**HEALTH & SAFETY EXECUTIVE
NUCLEAR DIRECTORATE
ASSESSMENT REPORT**

Step 2 WEC – AP1000 Civil Engineering and External Hazard Assessment

Figure 1 Comparison of AP-1000 Design Spectra with various UK site Response Spectra

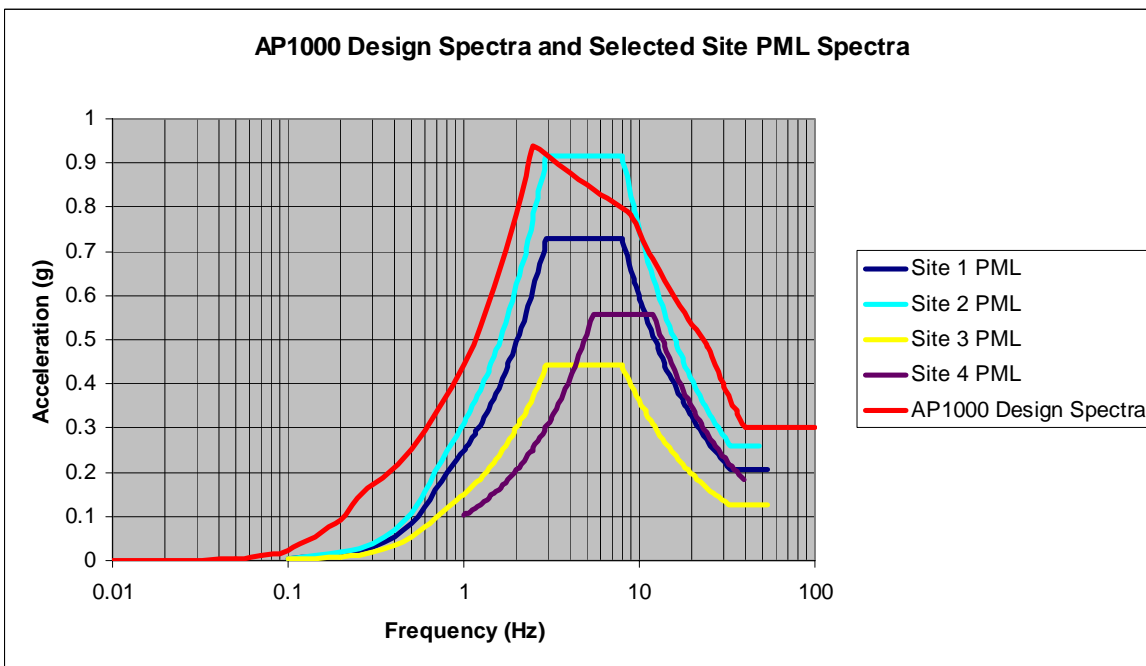
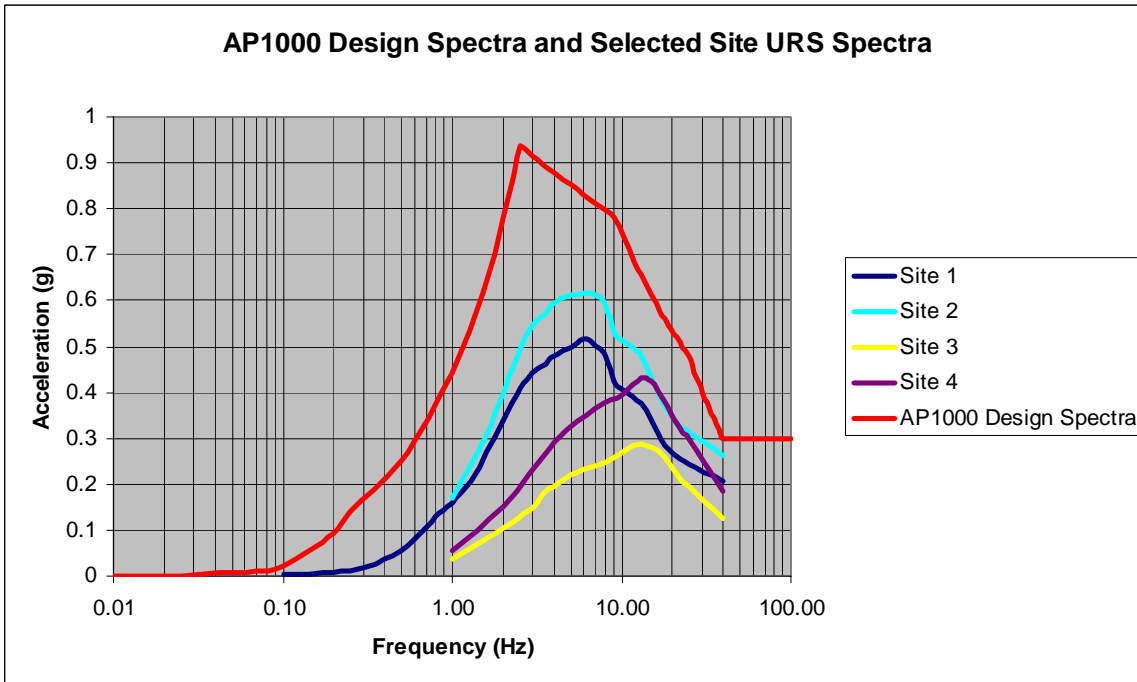
WEC claim that the AP1000 design has addressed these SAPs, Ref 5. The compliance document signposts to the external hazards that have been considered directly in the design basis of the plant, and also provides a synopsis of those hazards, which will be considered as part of the site licence application. The approach adopted is reasonable at the Step 2 stage, however a more considered view over the application into the UK situation will be required at the Step 3 assessment, and for the Step 4 considerable attention will be required in this area. Figure 1 in this report shows a basic comparison of the seismic design basis for the AP1000 as compared against a selection of 4 UK sites. As can be seen, it is not apparent that the design envelopes all sites from this simple comparison.

Observation 2 The design criteria have been clearly laid out, however there is no attempt to rationalise the application to the UK, either by inclusion or exclusion of areas/sites
